PHASE I GRADING & DRAINAGE PLAN
EVER READY OIL
EDITH & CANDELARIA

JOB NO. 920393
DATE 09-1993
SHEET 1 OF 2

PHASE II: GRADING & DRAINAGE PLAN
EVER READY OIL
EDITH & CANDELARIA

DRAINAGE PLAN CALCULATIONS & NOTES
EVER READY OIL
EDITH & CANDELARIA

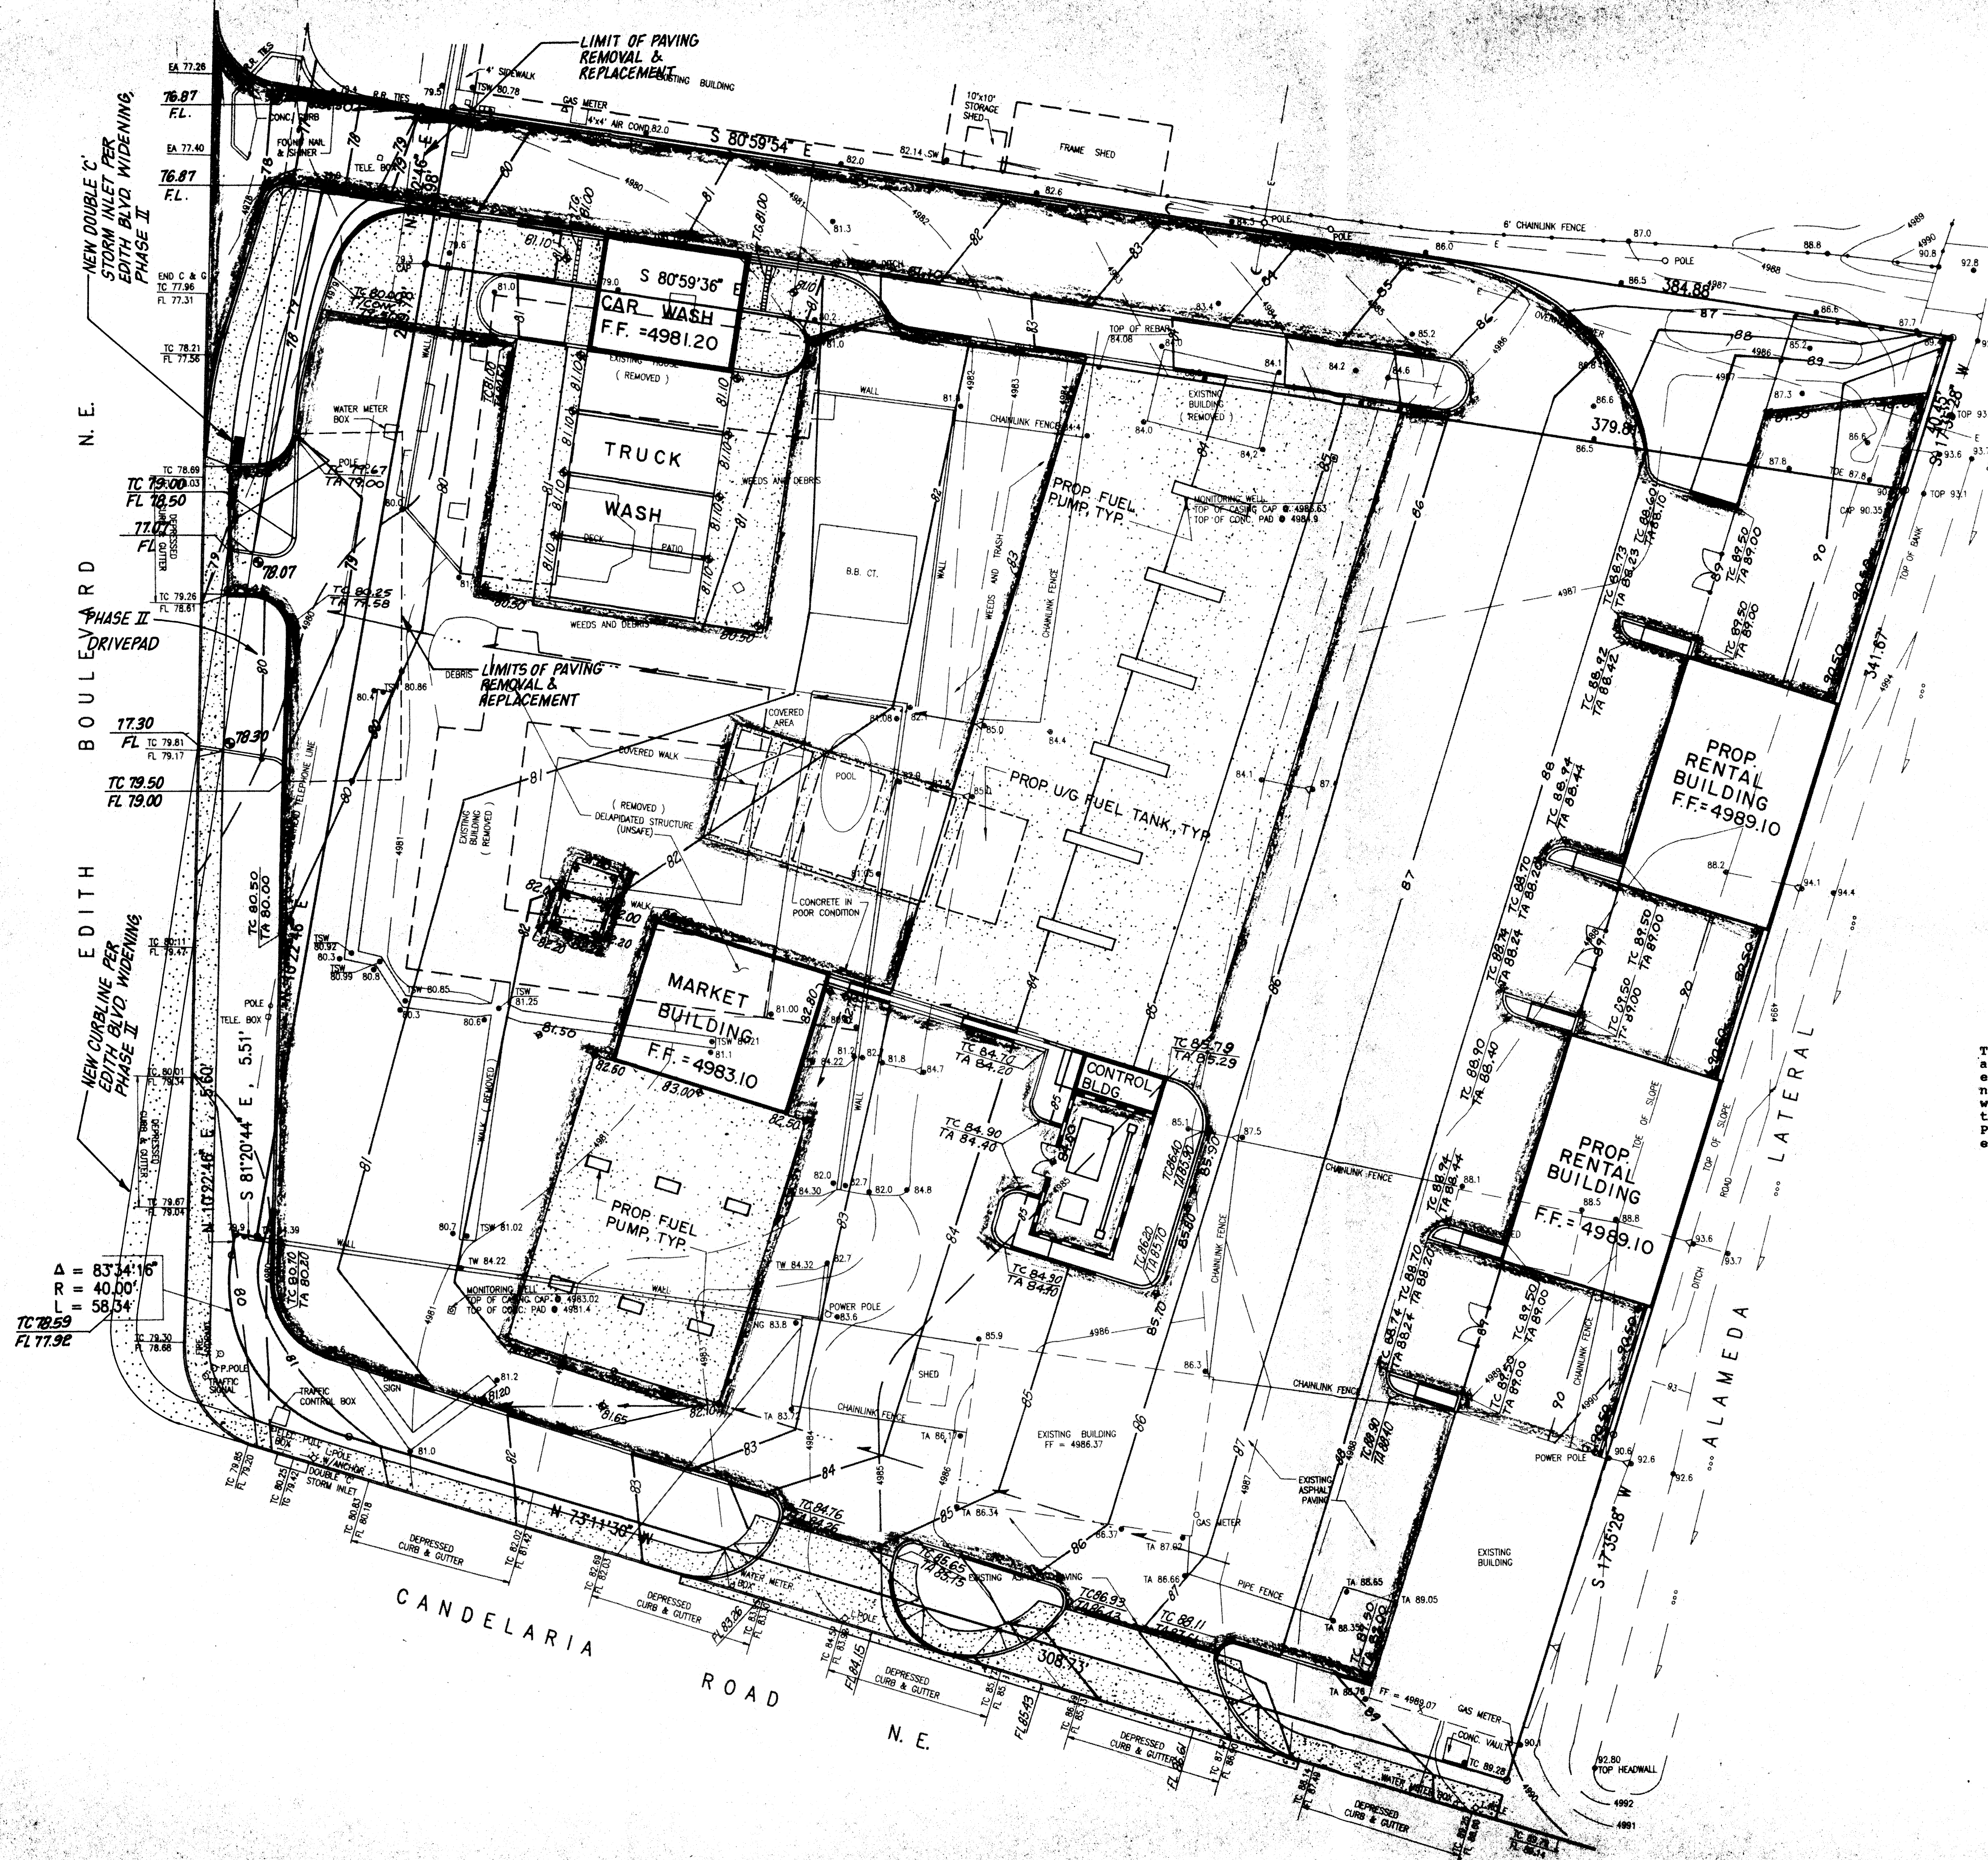
Text Revision and Additional Calculations

this plan has been modified to reduce the amount of runoff discharged from the site during more frequent rainfall events. A pond was created within the west landscaping area which fronts Edith Boulevard N.E. This pond has the capacity to hold the first 2,260 cubic feet of runoff created by a rainfall event and also will serve to reduce the total volume discharged from the site by that same volume.

Runoff flowing west on the southern half of the site is concentrated into a flowline that is intercepted by a storm inlet. The discharge from this inlet is governed by the entrance condition of the 4" PVC storm drain which is connected directly to the existing double "c" storm inlet on Candelaria Rd. As shown by the calculations below, this storm drain system will lessen the discharge from this site by 0.9 cfs. Any flows exceeding 0.9 cfs will cause the inlet to back-up with runoff continuing past the inlet and discharge out onto Edith Boulevard.

$$A_{pond} = (0.5) [(A_{78} + A_{79}) (1.0) + (A_{79} + A_{79.6}) (0.6)]$$

$A_{79.6} = 2,300 \text{ sf}$
 $A_{79} = 1,640 \text{ sf}$
 $A_{78} = 520 \text{ sf}$
 $V_{pond} = 2,260 \text{ cf}$

$$Q = CA(2gh)^{1/2}$$

$C = 0.6$
 $A = 0.087 \text{ sf}$
 $d = 4.53 \text{ ft}$ (from center of 4" PVC to top of grate)
 $g = 32.2 \text{ ft/s}^2$
 $Q = 0.9 \text{ cfs}$

PHASE I GRADING & DRAINAGE PLAN
EVER READY OIL
EDITH & CANDELARIA

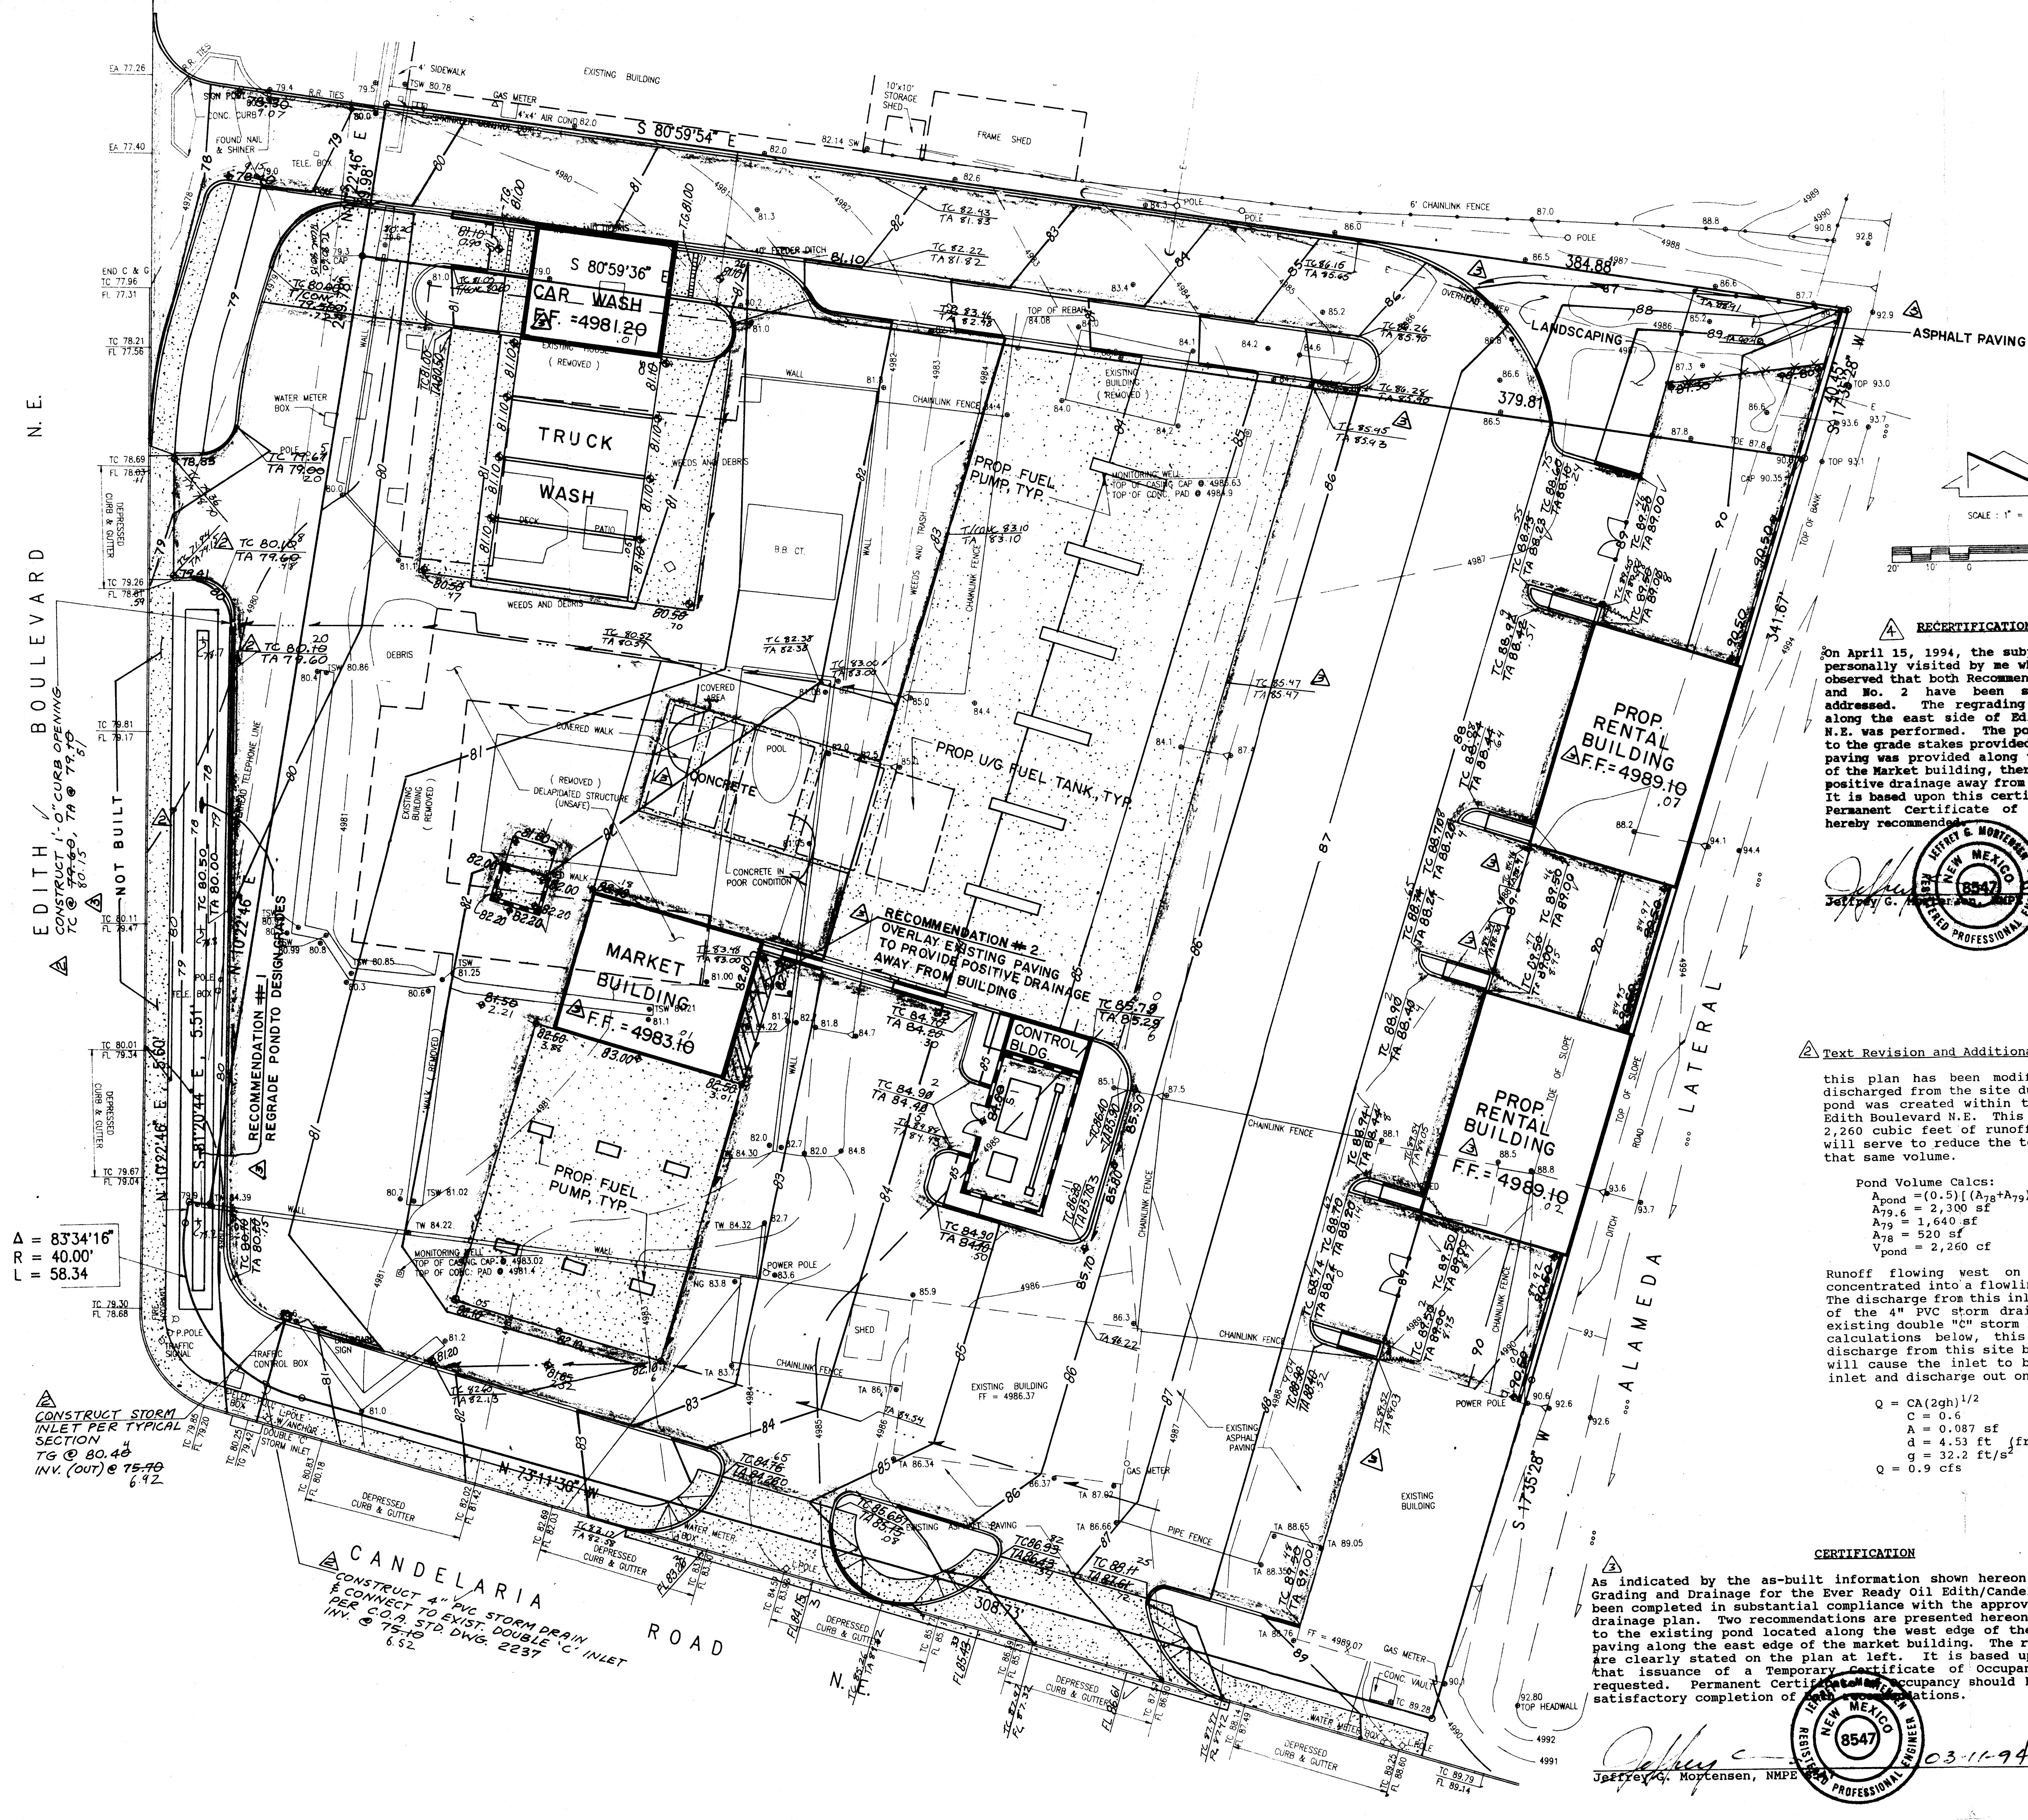
RECERTIFICATION
On April 15, 1994, the subject site was personally visited by me whereby it was observed that both Recommendations No. 1 and No. 2 have been satisfactorily addressed. The regrading of the pond along the east side of Edith Boulevard N.E. was performed. The pond was graded to the grade stakes provided. Additional paving was provided along the east side of the Market building, thereby promoting positive drainage away from the building. It is based upon this certification that Permanent Certificate of occupancy is hereby recommended.

CERTIFICATION
As indicated by the as-built information shown hereon, the Phase I Grading and Drainage for the Ever Ready Oil Edith/Candelaria site has been completed in substantial compliance with the approved grading and drainage plan. Two recommendations are presented hereon which pertain to the existing pond located along the west edge of the site and the paving along the east edge of the market building. The recommendations are clearly stated on the plan at left. It is based upon the above, that issuance of a Temporary Certificate of Occupancy is hereby requested. Permanent Certificate of occupancy should be issued upon satisfactory completion of the above recommendations.
